418 86-106-A **PETITION FOR ZONING VARIANCE** TO THE ZONING COMMISSIONER OF BALTIMORE COUNTY:

ATTACHMENT TO PETITION FOR ZONING VARIANCE

PLAT TO ACCOMPANY PETITION
FOR
PARKING VARIANCE
VICINITY
300 BLOC GOUCHER BOULEVARD
ELECTION DISTRICT 9 BALTIMORE COUNTY, MD.
DATE: MAY 28, 1985
SCALE: 1"=50'
REVISOR: JULY 10, 1985

RE: PETITION FOR VARIANCES : BEFORE THE ZONING COMMISSIONER
SW Corner of Joppa & Prince :
Rds. (900 Block of Goucher : OF BALTIMORE COUNTY
Blvd.), 9th District

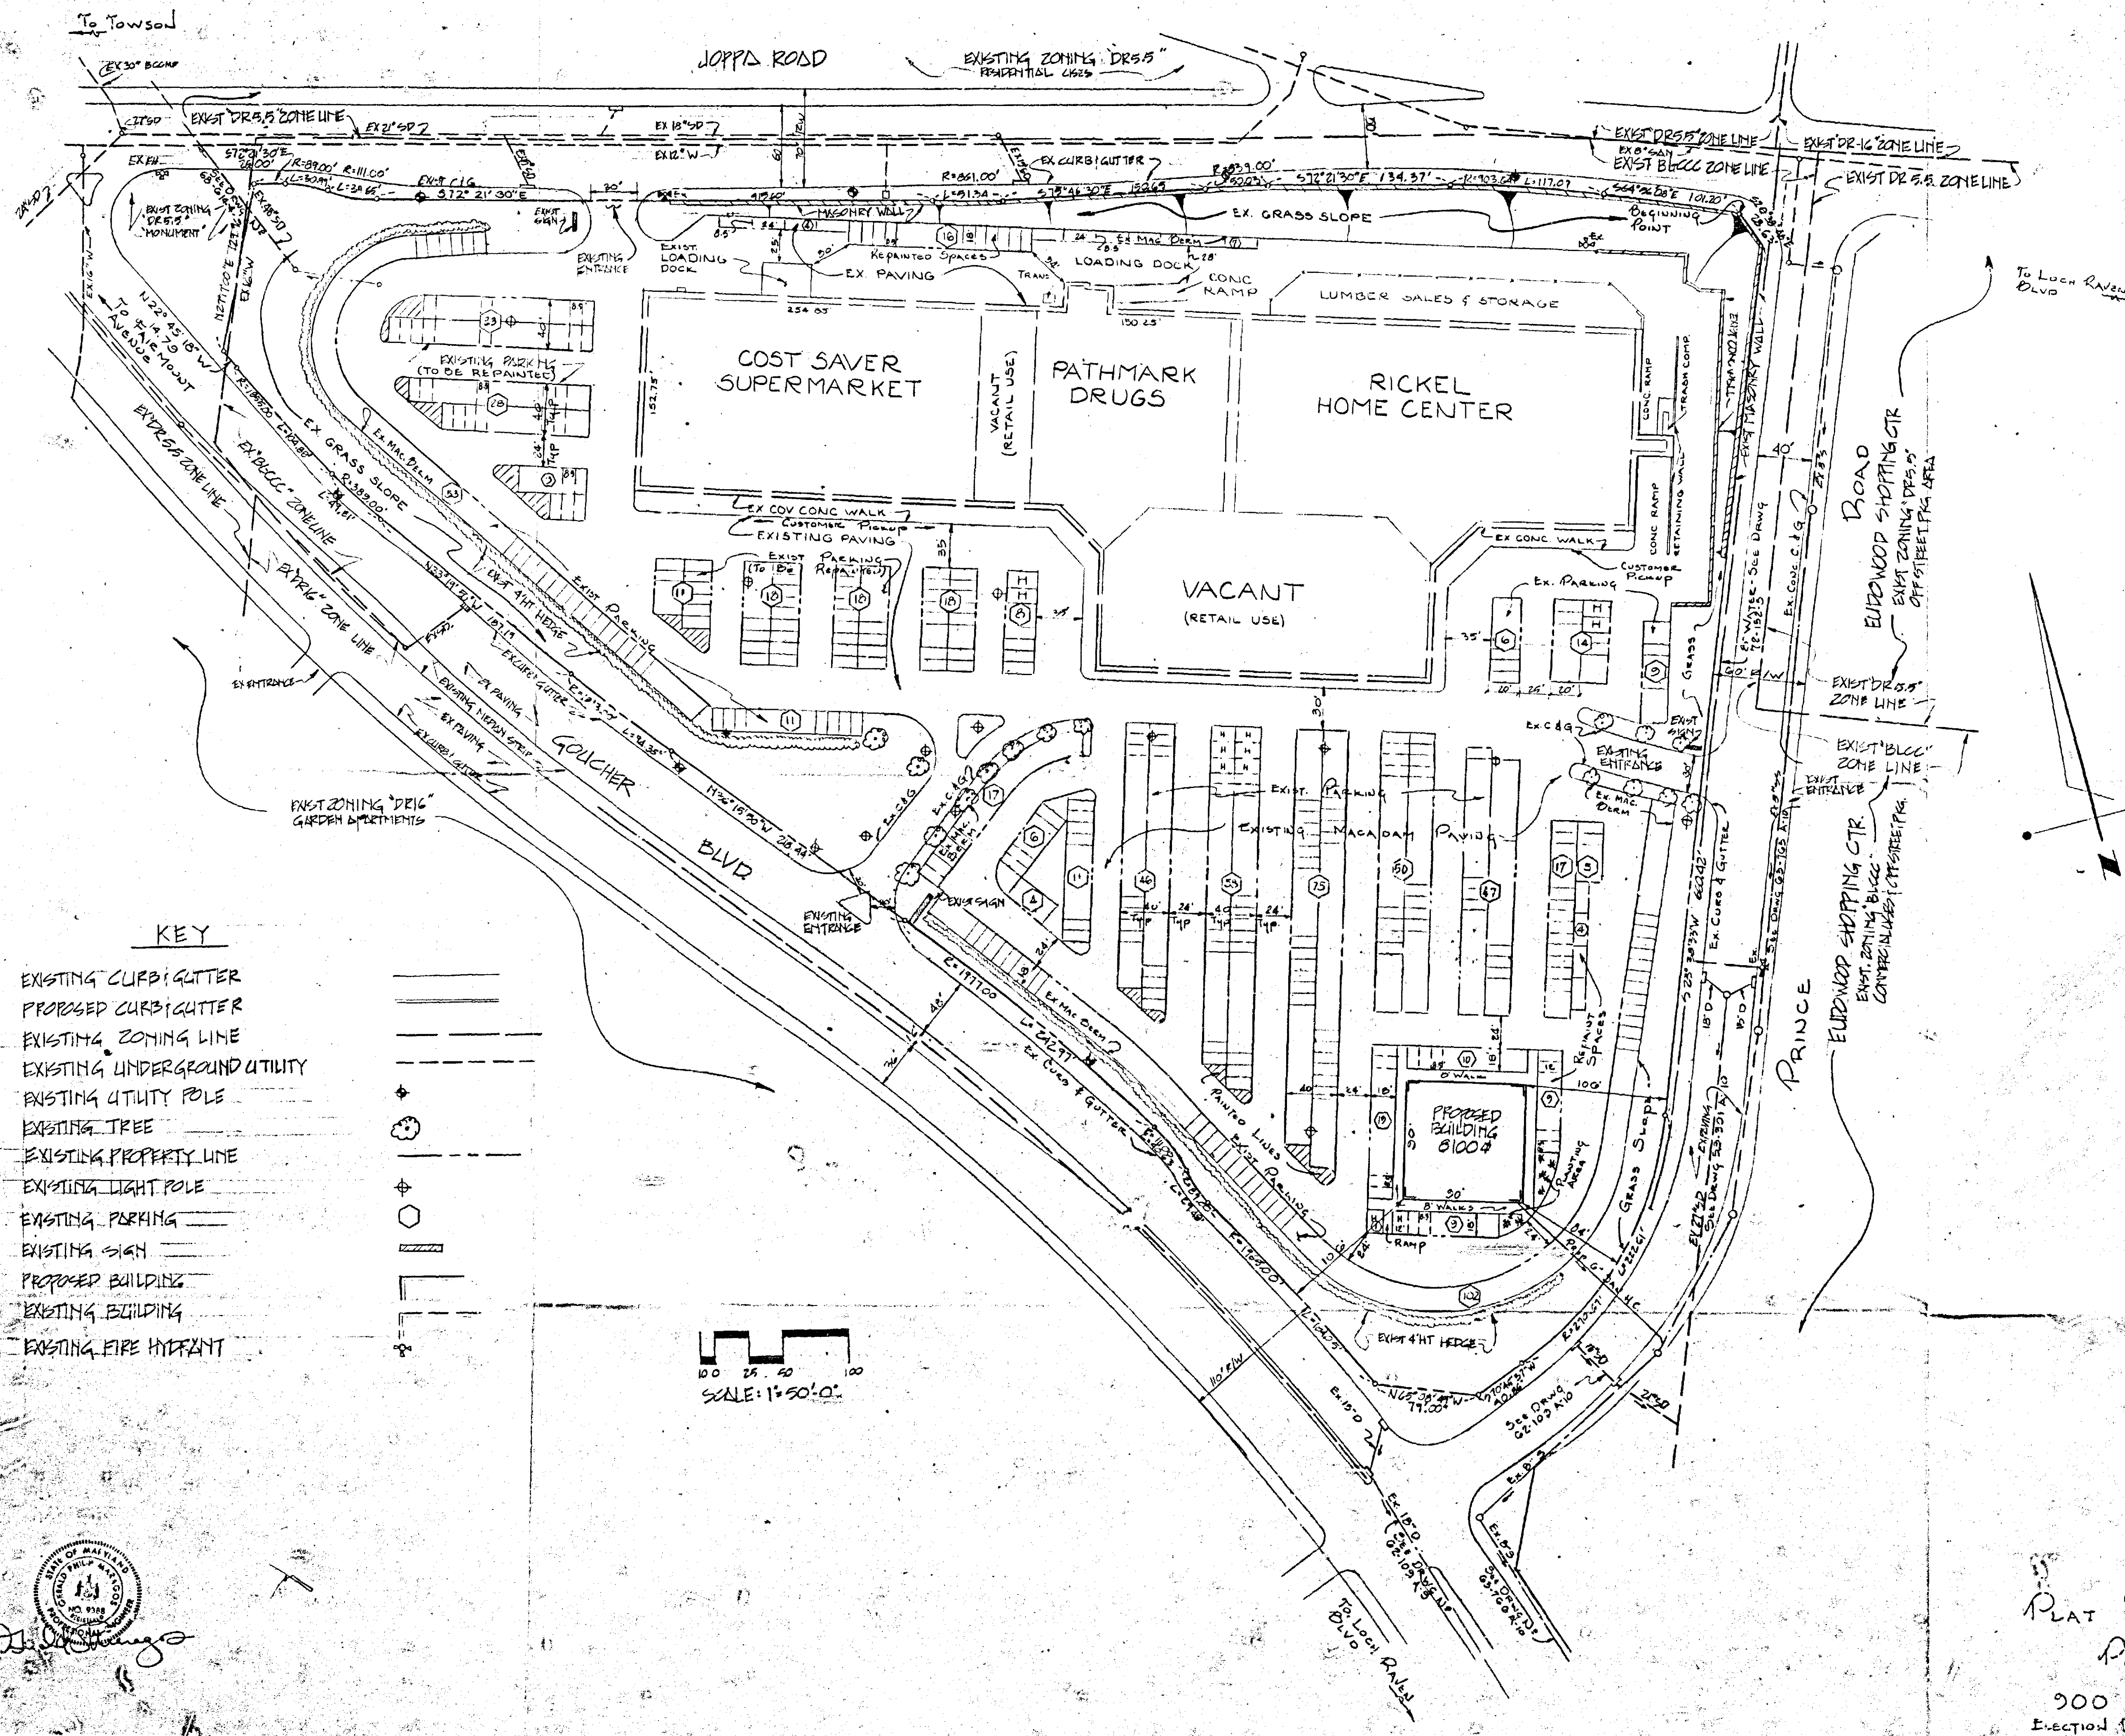
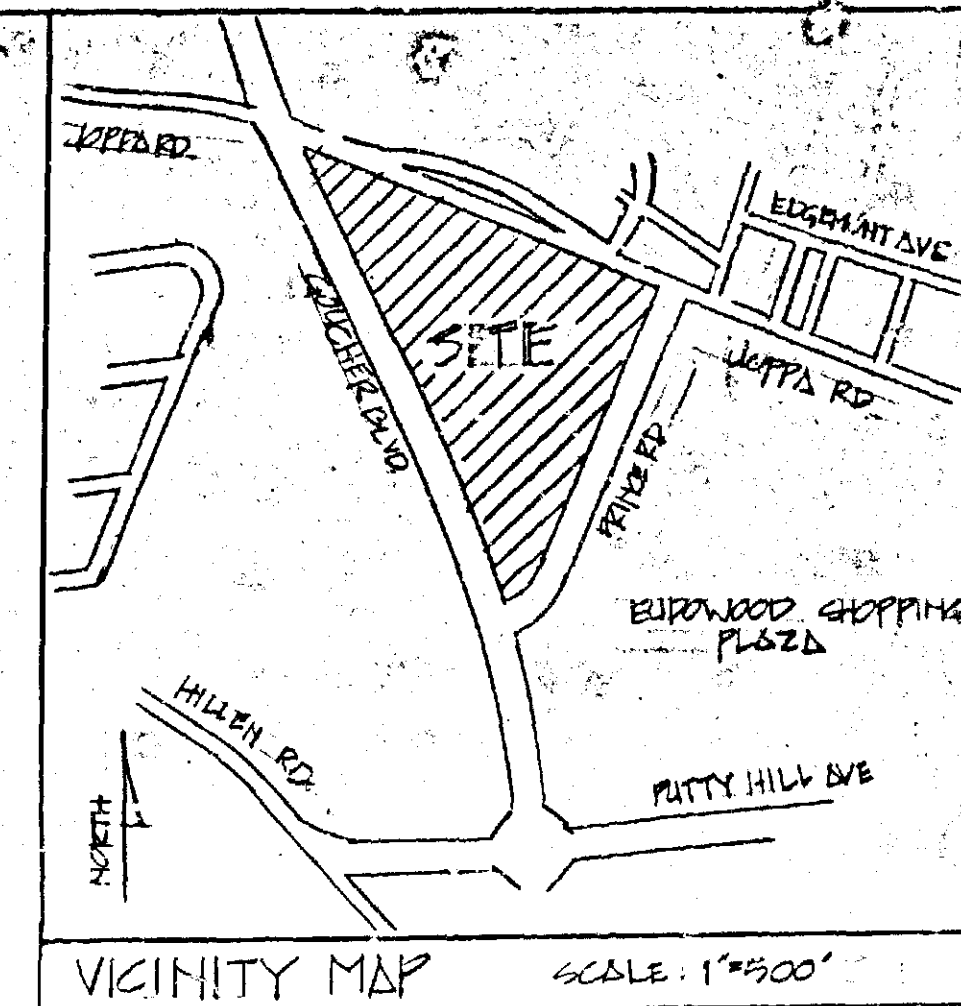
(6) The structure does not appear to comply with Table 505 for permissible height/area. Reply to the requested variance by this office cannot be considered until the necessary data pertaining to height/area and construction type is provided. See Table 101 and 505 and have your Architect/Engineer contact this department.

(9) The proposed project appears to be located in a Flood Plain, Flood/Drainage. Please see the attached copy of Section 216.1 of the Building Code as adopted by Bill #17-85. Site plans shall show the correct elevations above sea level for the lot and the finish floor levels including basement.

☒ This site is part of a larger tract therefore it is defined as a subdivision. The plan must show the entire tract.

☒ Parking calculations must be shown on the plan.

1. The plan shall be revised to show a 6800 square foot building, 85 feet on the north and south and 80 feet on sides.
2. A directional sign indicating "no left turn" or "right turn only" shall be placed at the exit onto Prince Road.
